## **PROPOSED CHANGE OF SPEED LIMIT – DOVER HILL AND NEW DOVER ROAD**

To: **Folkestone and Hythe Joint Transportation Board – 2 July 2018**

**Summary:** This report gives details of the statutory consultation for a proposal to reduce the speed limit in part of New Dover Road and Dover Hill as part of a Crash Remedial Scheme.

Appendix A – Plan of Proposals

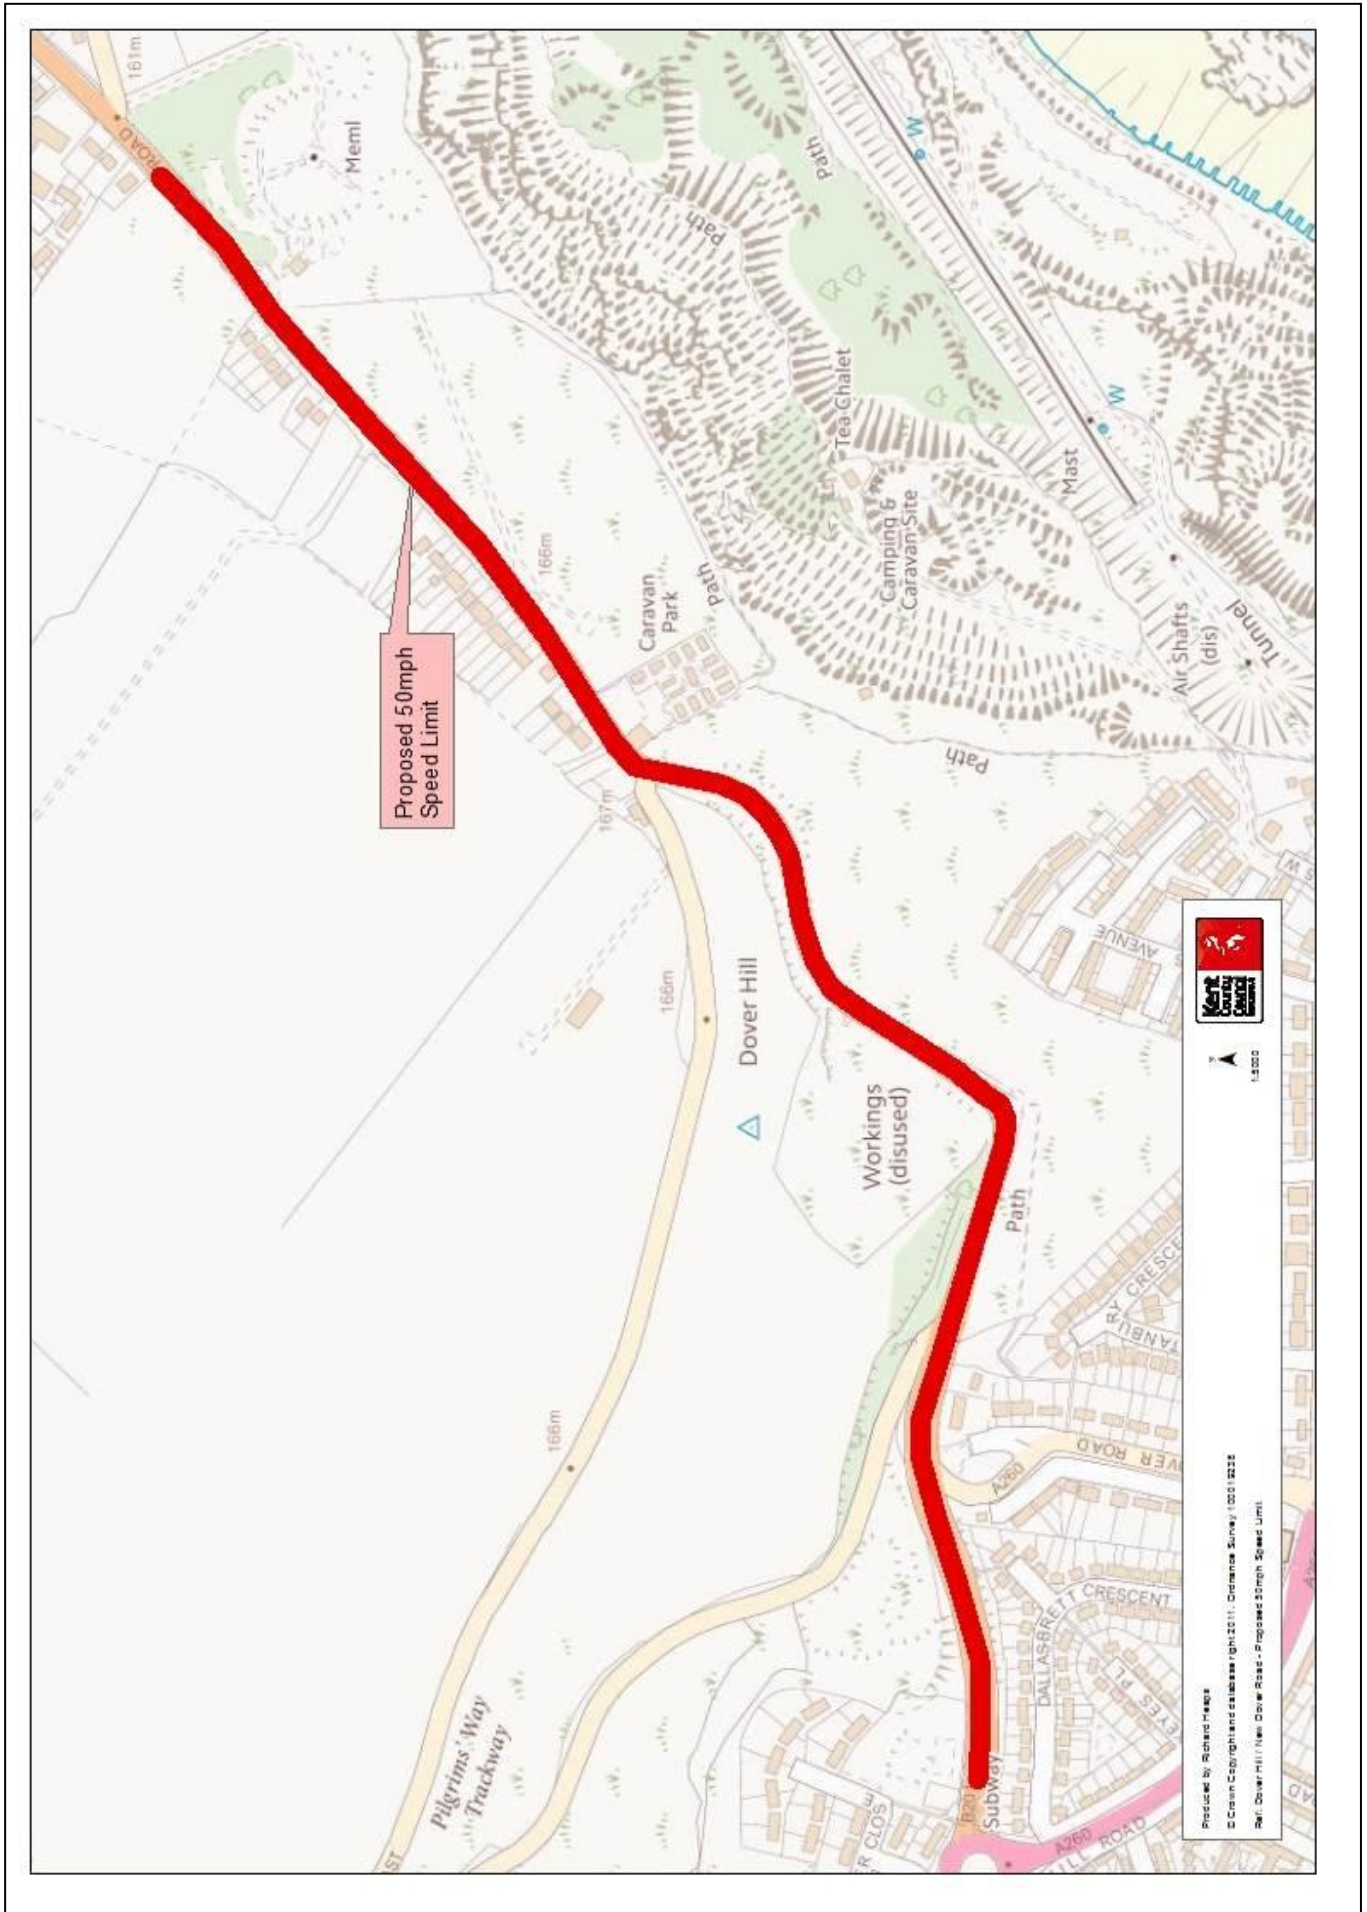
Comments	KCC response
<ul style="list-style-type: none"> <li>• Would like the speed limit to be reduced to 40mph, especially by the entrance to the Battle of Britain memorial.</li> </ul>	<ul style="list-style-type: none"> <li>• See comments in paragraphs 1.4, 1.5 &amp; 1.6 regarding the speed limit.</li> </ul>
<ul style="list-style-type: none"> <li>• Can't see why a reduction in the speed limit is necessary.</li> </ul>	<ul style="list-style-type: none"> <li>• The proposal is being made as part of a Crash Remedial Measures scheme.</li> </ul>
<ul style="list-style-type: none"> <li>• The two lanes up Dover Hill should be reduced to one lane further down the hill.</li> </ul>	<ul style="list-style-type: none"> <li>• Although the physical narrowing of the road width is outside the budget for these works, an additional merging arrow will be introduced to encourage traffic to merge earlier. There are existing warning signs in place.</li> </ul>

<ul style="list-style-type: none"> <li>• Speed limit on Dover Hill should be</li> </ul>	<ul style="list-style-type: none"> <li>• A 30mph speed limit would be an</li> </ul>

30mph.	unrealistically low speed limit for Dover Hill given its nature and characteristics, and therefore there would be a high level of non-compliance.
•The speed limit should be reduced along the whole of the B2011 New Dover Road.	•The scope of these works is only for Dover Hill and the adjoining section of New Dover Road.

My view is that reducing the speed limit from 60mph to 50mph is not enough. I really think that should be reduced to 40mph. Considering all the bad bends on the hill and the amount of residents that have to negotiate getting in and out of their properties from both sides of the busy road and also of the other road's junctions that brings a lot of traffic on to it.

I would respectfully suggest that the existing 40 mph speed limit that currently starts 5 metres southwest of the southwestern boundary of No 101 New Dover Road be extended south west to encompass the entrance to the Battle of Britain memorial site and also the entrance to the farm ( No 12 New Dover Road) that was recently given KCC approval for waste collection to the east of No.8 New Dover Road. This would improve the safety access from these sites onto the New Dover Road.

1. There are residential entrances and exits on both sides of New Dover Road.
2. Crossing the road to/from the bus stop so near the corner and junction between New Dover Road, Dover Hill and Crete Road East is frightening, especially for the elderly residents who use walking aids. If any member of my family is injured, this email will serve as evidence that KCC is aware.
3. Cars frequently lose control when rounding the corner at the top of Dover Hill/New Dover Road, clipping the kerb and spinning onto the pavement, into the road to through fences. Many of these are not officially recorded since, by luck not judgement, injuries are not KSI. We have had two this week, one of which required the police and fire brigade.
4. The corners up Dover Hill are not safe if taken at 50mph; there is a history of cars losing control/rolling over when taking the bends too fast

Although the reduction in speed will help, the current reduction of two lanes to one at the top of the hill is far too close the Crete Road East Junction, resulting in frequent accidents.

At the meeting held on the 20<sup>th</sup> February, Capel-le-Ferne Parish Council recommended that the speed limit **on the above section of road should be 40mph, so extending the existing 40mph zone.**

The reason that the Council support an extension of the 40mph limit is because there has been a number of minor accidents and near misses on this section of road, mainly due to vehicles/coaches accessing/egressing the Battle of Britain Memorial Site and Visitor Centre.

4.1 That the 50mph speed limit and additional lane merging arrow be installed as proposed.
